**Subject: TeamPoS 3600 – Legacy I/O Board Jumper Settings – Update A**

**Overview**

**Legacy I/O Board**

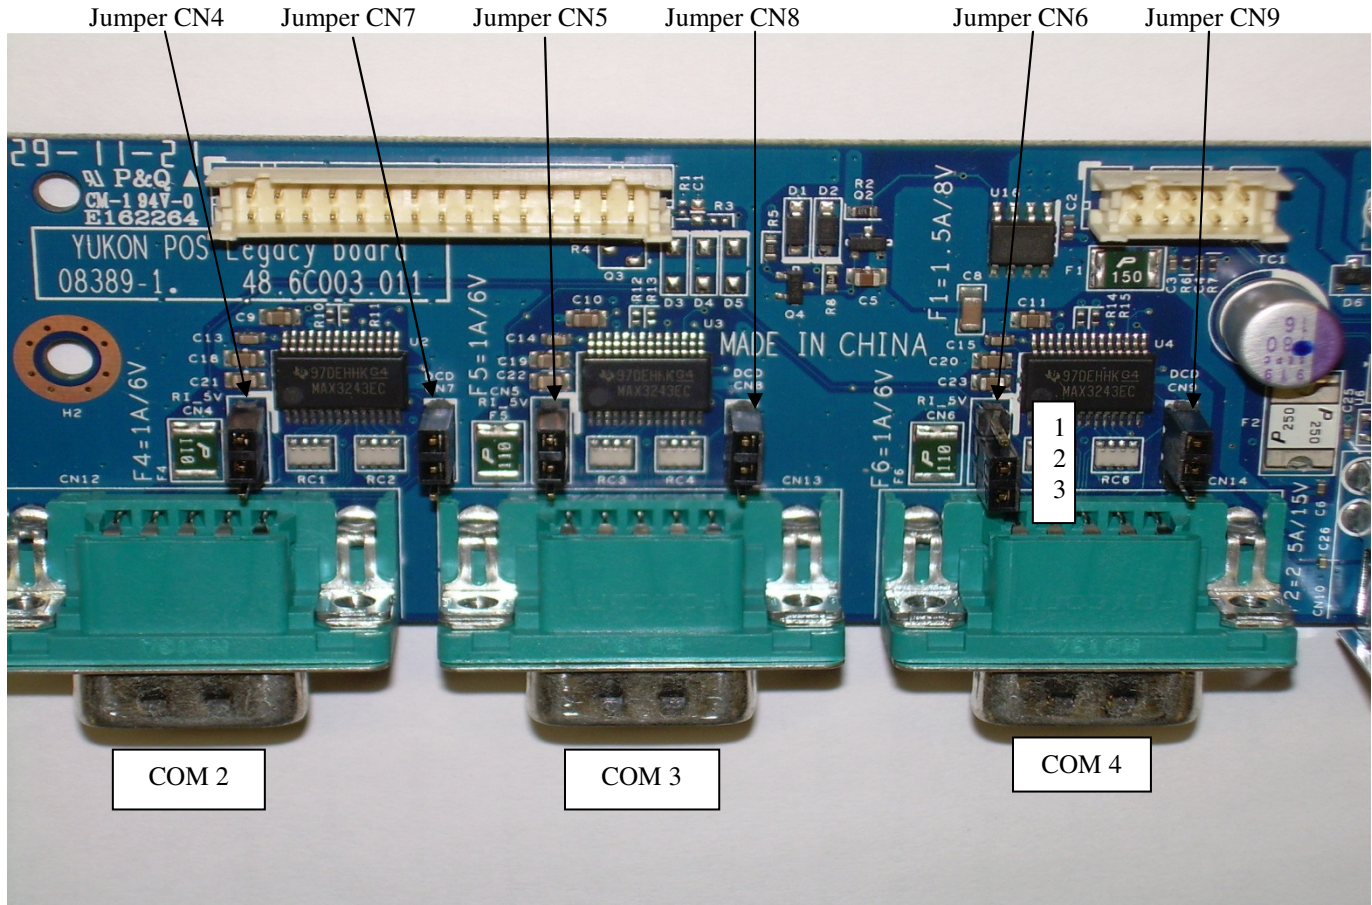
An error was found on the SPG and the Installation and Maintenance Manual in reference to the jumper settings on the Legacy I/O Board used on the TeamPoS 3600 terminal. Some earlier versions of this board also had the silkscreen printed on the board incorrectly. This caused some confusion as to which jumper was used for which purpose.

The jumpers that control the outputs on pin 1 and pin 9 of the Legacy I/O board were inadvertently reversed on the silkscreen on the earlier boards, including preproduction boards. This caused the documentation in the SPG and the Installation and Maintenance Guide to show the incorrect jumper positions on the current production boards.

The jumper designations below are current production. The early boards, the designation was different but the jumper function per physical location was the same.

The Legacy I/O board contains six jumpers. Three of the jumpers (CN4, CN5, & CN6) will either provide +5 V on pin 9 of DB9 connector or provide the RI signal on that pin depending upon the jumper setting. If pins 1 & 2 are jumpered on CN4, CN5, or CN6 it provides (RI) on pin 9 of COM2, 3, or 4 respectively. If pins 2-3 are jumpered, it provides +5V to pin9 of the DB9 connector. Default is set as RI (pins 1&2 shorted) as shown in picture for CN4 and CN5. CN6 controls COM4 and is set for +5V in the picture below. Jumpers CN7, CN8, and CN9 enable the DCD signal on pin 1 of the DB9 connector and should remain in this default position if DCD is required.

Pin 9 Function Selection				
Jumper	COM	1-2	2-3	Default
CN4	2	RI	+5V	1-2
CN5	3	RI	+5V	1-2
CN6	4	RI	+5V	1-2
Pin 1 Function Selection				
Jumper	COM	1-2	2-3	Default
CN7	2	DCD	Open	1-2
CN8	3	DCD	Open	1-2
CN9	4	DCD	Open	1-2
